*Preliminary Consultation*  
**MONTGOMERY COUNTY HISTORIC PRESERVATION COMMISSION**  
**STAFF REPORT**

<b>Address:</b>	21 Grafton St., Chevy Chase	<b>Meeting Date:</b>	5/7/2019
<b>Resource:</b>	Contributing Resource Chevy Chase Village Historic District	<b>Report Date:</b>	4/30/2019
<b>Applicant:</b>	Duane and Paula Gibson (Doug Mader, Architect)	<b>Public Notice:</b>	4/23/2019
<b>Review:</b>	Preliminary Consultation	<b>Staff:</b>	Dan Bruechert
<b>PROPOSAL:</b>	Building Addition and accessory structure removal and construction, and other alterations

The applicant proposes work in three areas. First, the applicant proposes to remove the non-historic screened-in porch and to construct a new rear addition and deck. Second the applicant proposes to demolish the existing garage/accessory structure and construct a larger one in the

Figure 5: 1927 Sanborn map showing 21 Grafton St (co-listed as 19) with a porch projection in the northwest corner.

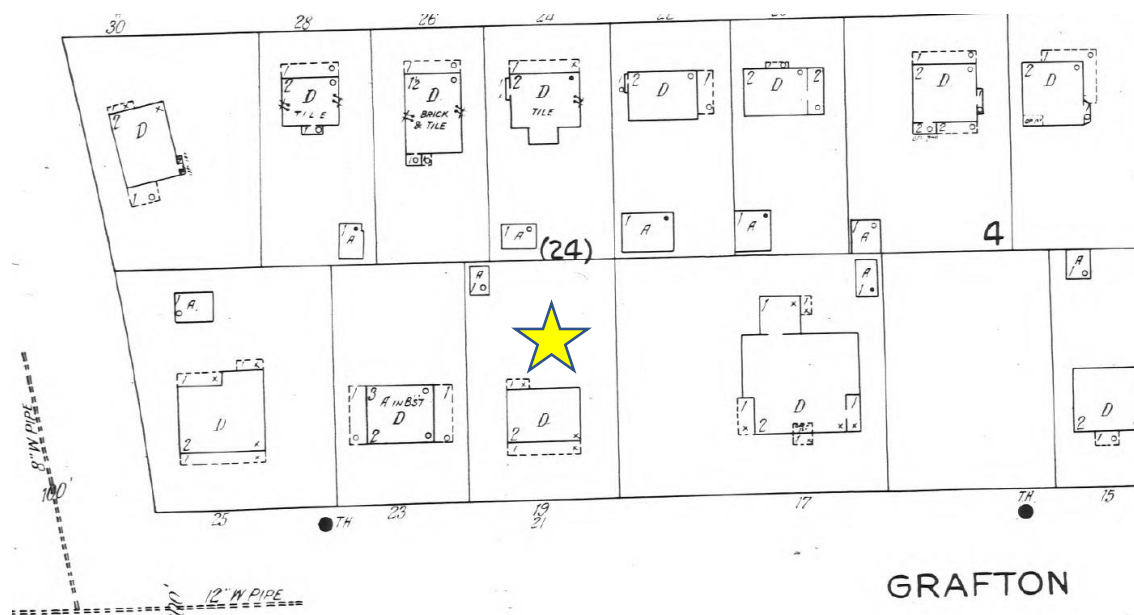
The applicant has indicated a desire to retain the rear projection in the northwest corner of the house, which is why the design shifts the massing of the addition to the east (right). Staff could potentially support this justification; however, the Sanborn Map shows that the feature was a porch in 1927, and the house foundation changes from continuous stone to wood piers, suggesting change in construction. Staff has not fully evaluated the window in this room, but suspects that it could be identified as a non-historic wood window and was installed when the rear porch was enclosed. Staff welcomes additional information that could confirm that this feature is in its historic configuration, which would provide additional justification for retaining the space. In the absence of that information, Staff recommends that the one-story rear addition be removed, and the rear addition be shifted west so that it is fully behind the historic massing. The HPC typically requires that rear additions be inset from the historic wall planes to better differentiate the new construction from the historic and to ensure that the new construction does not overwhelm the historic.

In consultation with Staff the applicant notes that their desire was to construct an addition that did not project further into the rear of the yard, because they desired to retain more rear yard and already felt constrained because the houses to the rear have rear additions and accessory structures constructed virtually at the property line. Staff can confirm that it appears as though the accessory structures to the rear were installed at less than the 5' setback currently required. This is detailed in the photos submitted with the application and in the aerial photo below. Staff finds that a deeper addition could have a negative impact on the park-like character of the surrounding district, but does not find this to be a sufficiently compelling argument to have an addition project beyond the historic wall plane.

*Figure 6: Detail of map showing the subject property and the surrounding buildings, their additions, and accessory structures.*

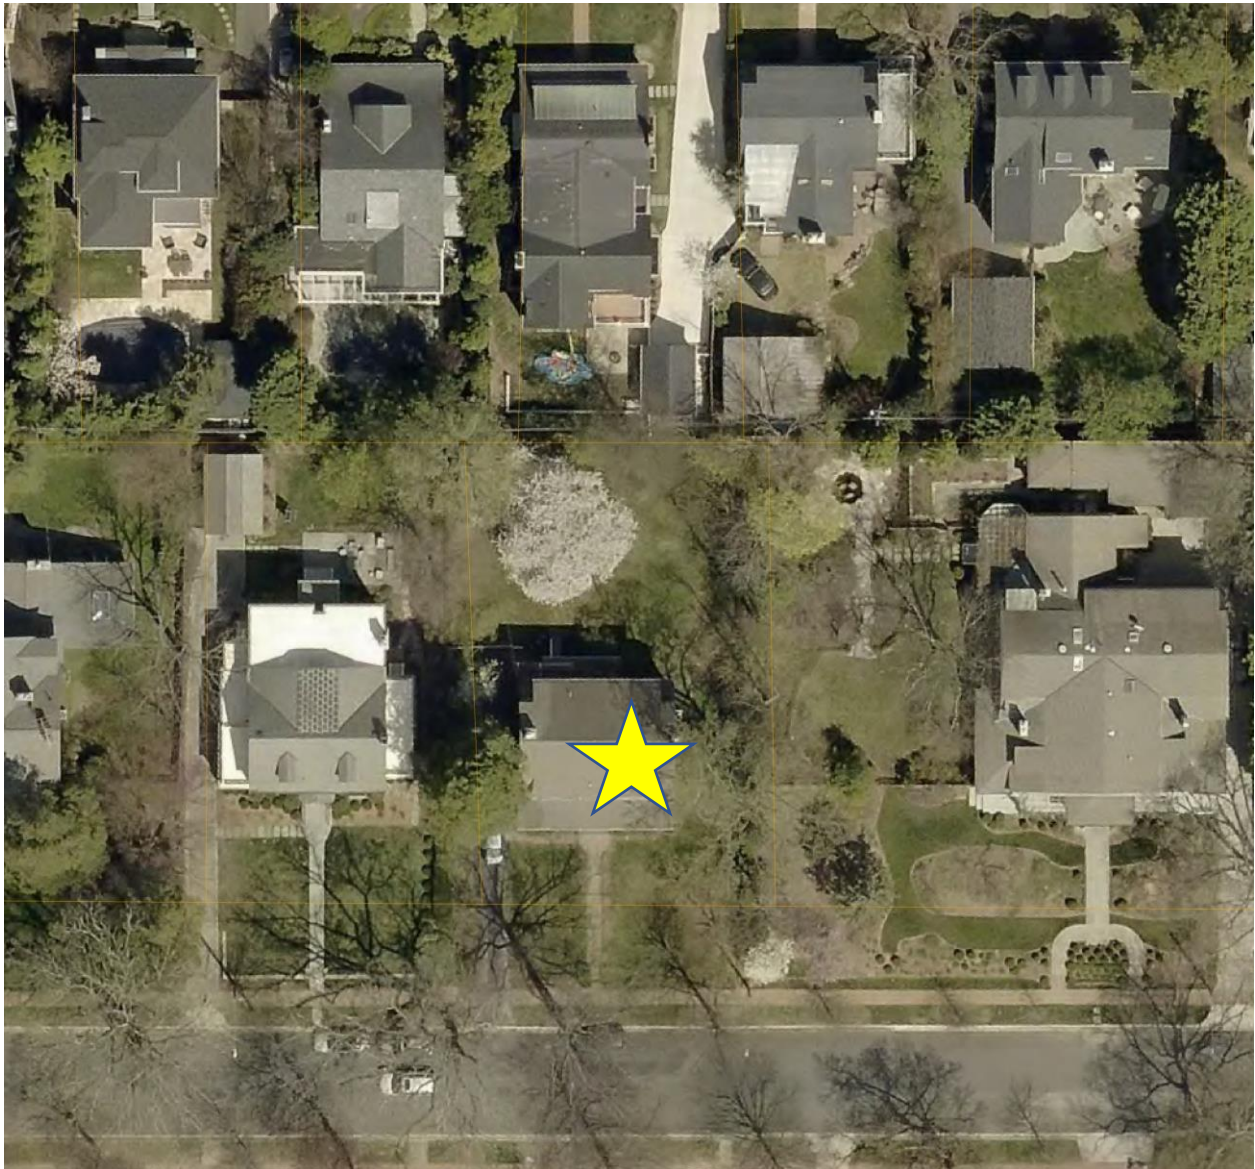
Staff requests the HPC provide feedback on the appropriateness of the side projecting rear addition of if the addition should be placed entirely behind the historic massing.

# FRONT ELEVATION

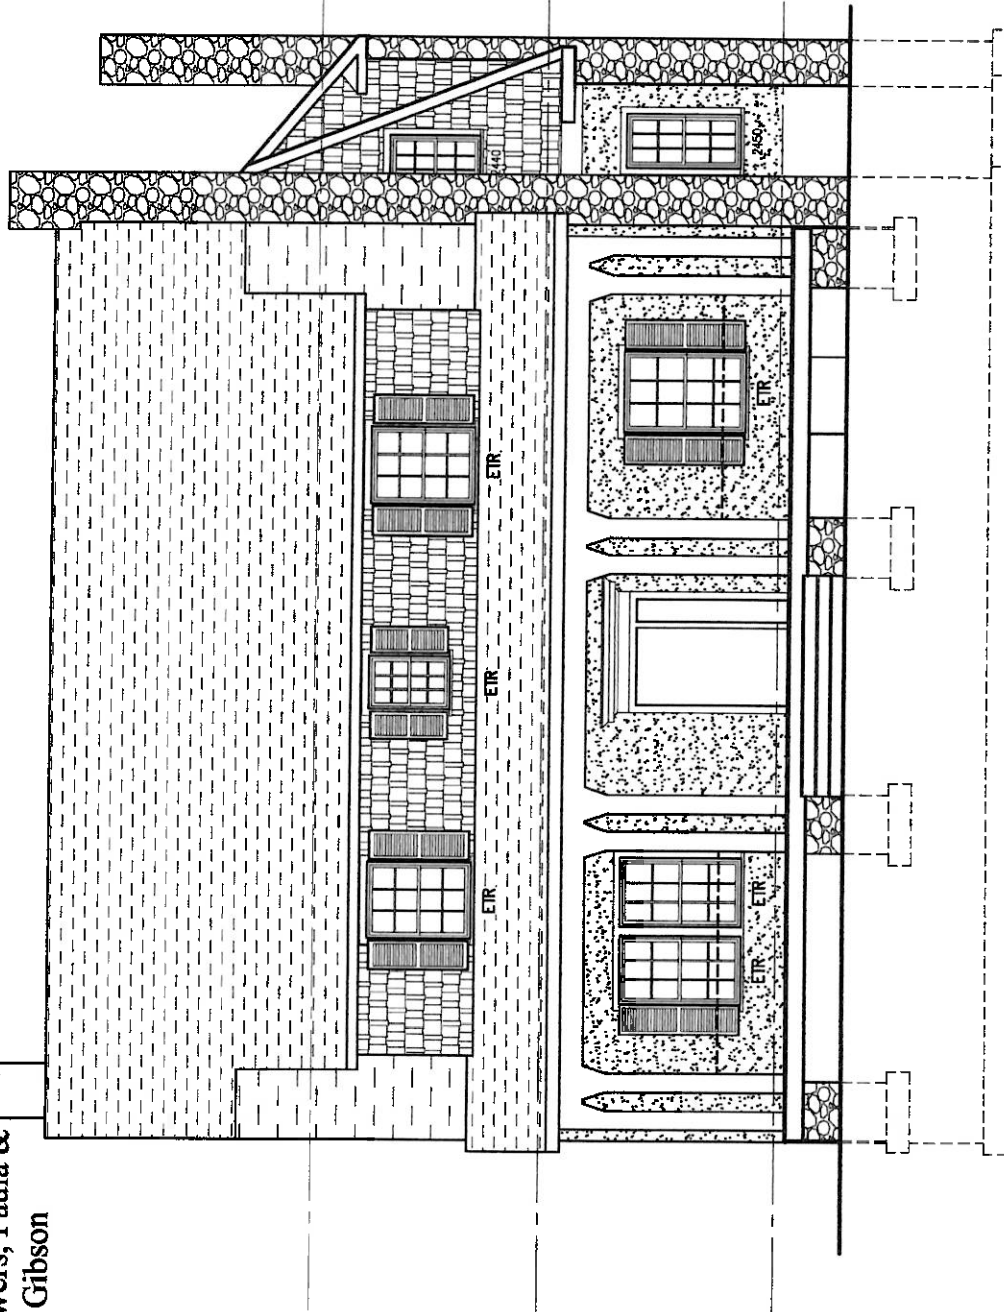
The second proposed change is to replace the front porch steps with code-compliant steps in wood. The submitted drawings only show that the staircase will have an additional step and do not detail a railing for this feature. Staff finds that with an appropriately detailed railing, this alteration would not have a significant impact on the historic character of the house or surrounding district. Staff recommends that a railing detail be submitted for review as part of a second preliminary consultation.

# RIGHT ELEVATION

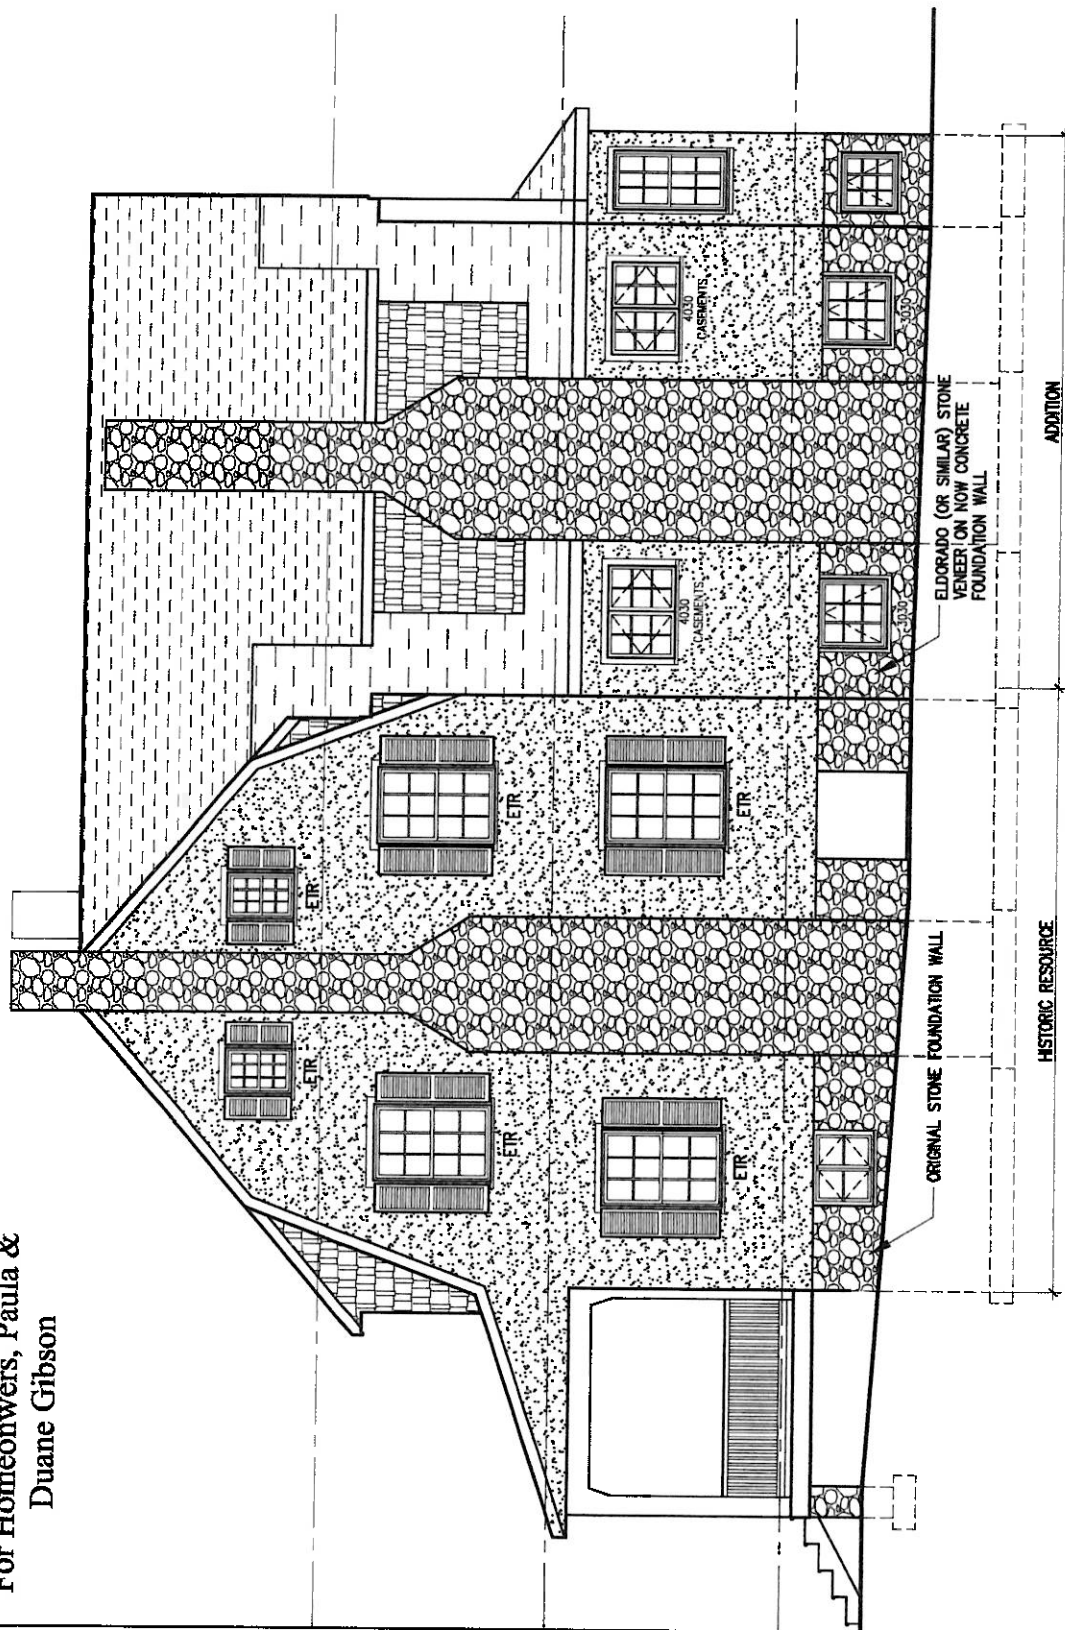
The one outstanding issue is that the addition will be offset so that it projects to the right of the east (right) historic wall plane. The first-floor plan will project by 6' (six feet), but due to the gambrel overhang, the second will project by 7' 2" (seven feet, two inches). Due to the house placement on the lot and the topography this projection will be visible from the right-of-way when evaluated in the absence of vegetation.

# REAR ELEVATION

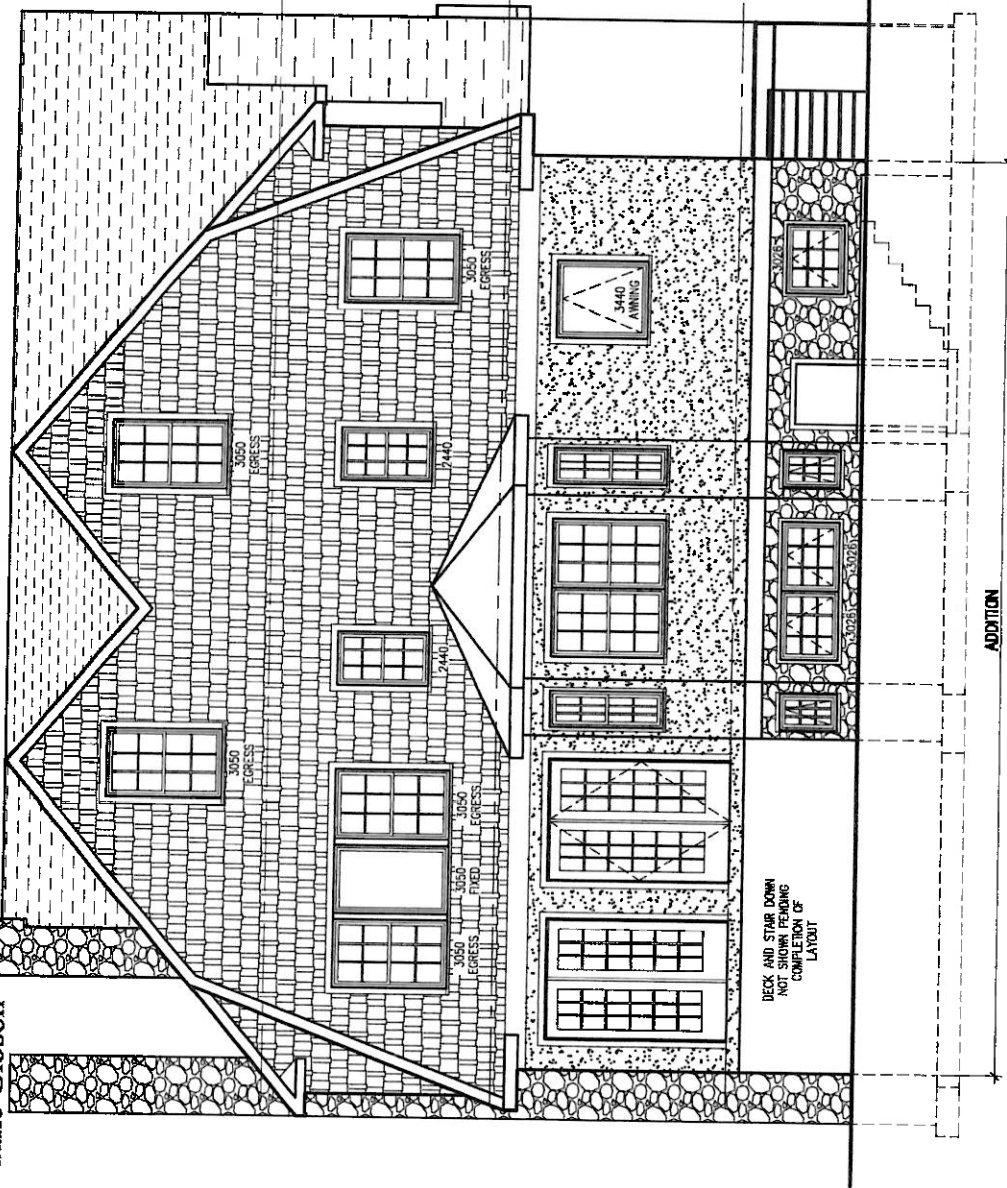
The rear-facing roof of the addition, which is best described as a butterfly or double gambrel form, will match the height of the historic gambrel roof ridge. Staff remains uncertain as to the appropriateness of this roof form and height, and the impact it will have on the massing of the addition from the right-of-way. Typically roof additions should have ridgelines that are lower than that of the historic resource, and these additions should be designed so that newer or more elaborate roof forms are not introduced. Staff recommends the HPC request perspective drawings that show the view from the southeast and south west to better evaluate the massing of the proposed rear addition. This perspective drawing should be accompanied with a roof plan for the house.

POSSIBLE SHED/GARAGE DESIGN

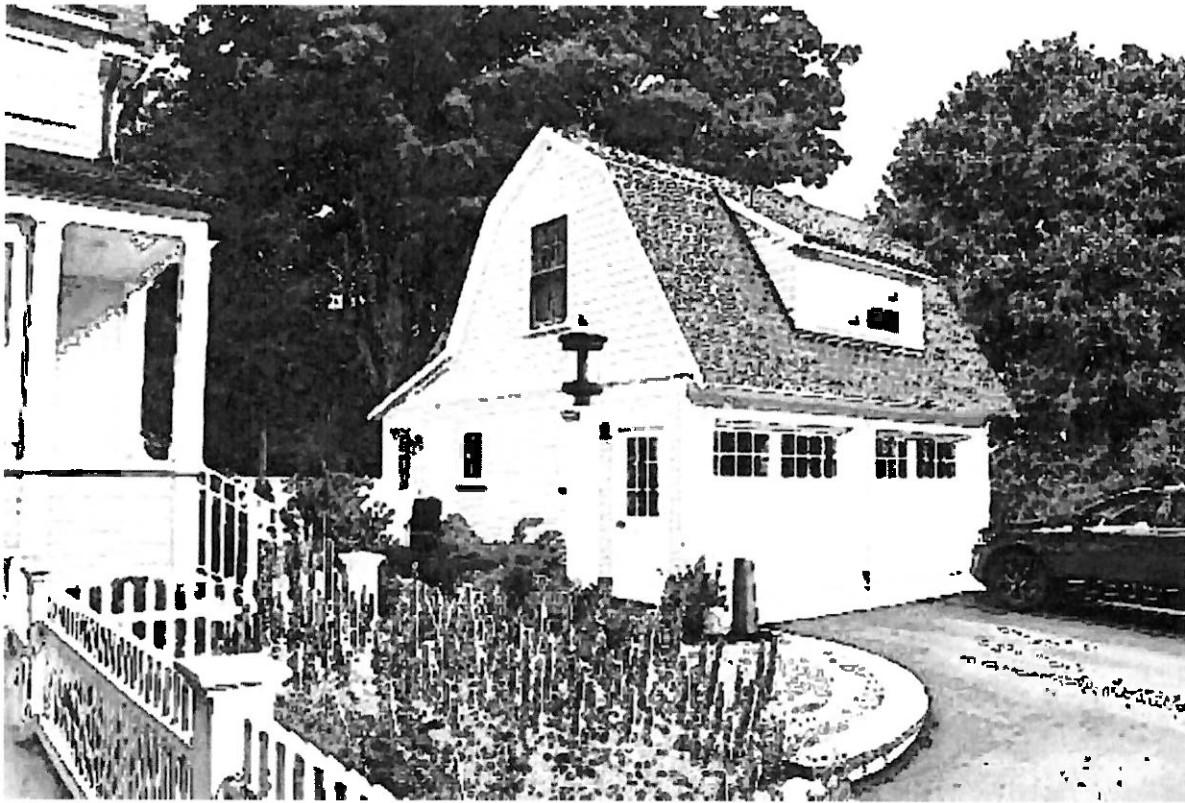
In place of the existing structure the applicant proposes to construct a new two-bay garage that will measure approximately 28' × 22' (twenty-eight feet by twenty-two feet). The concept shown has a one-and-a-half story tall gambrel roof with some type of clapboard siding and carriage-style doors. The existing asphalt drive will need to be extended to provide access to this new structure. The *Design Guidelines* require that detached garages are to receive lenient scrutiny and that they should be approved unless there are major problems with the size, scale, and massing of the proposal.

Staff finds that the placement and architectural details of the proposed garage are appropriate but is unsure if the height is out of character with the house and surrounding district. The height of the proposed garage was not included with the submission which would help better evaluate the proposal. However, Staff's windshield survey of the surrounding district demonstrated that the majority of garages were only one-story and a garage taller than that may be out of scale with the surrounding district. Staff recommends that the applicant make revision to the garage concept so that it is only one story tall.

Staff request the HPC provide feedback on the proposed garage, including recommendations for any materials used on a new garage and a determination of whether extending the asphalt drive is appropriate or if some other material should be used to provide access to the rear.
